Access Compliance Report

Public Rights-of-Way

| Intersection ID: 44539 | Main Street: FORUM_AV | Cross Street: BALLANTYNE_COMMONS_PY | Location: NE |
| ADA ID: 1DD4A5722DB1 | Ramp Type: Perp | Initial Pass/Fail: Fail | Overall Compliance: No |

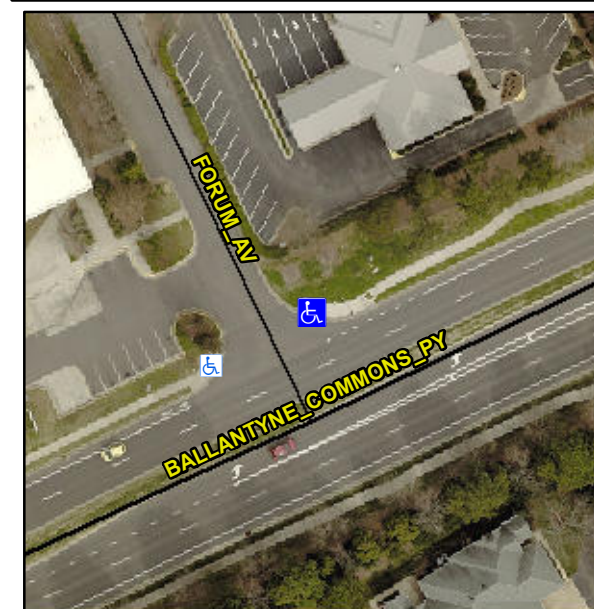
Not Found, R304.5.1, R304.5.3

| Compliance | Description | Data | Compliance | Description | Data |
|------------|-----------------------|------|------------|-----------------------------|------|
| No | Ramp Width (in) | 47.0 | No | Ramp XSlope (%) | 10.3 |

Remove & Replace Entire Ramp.
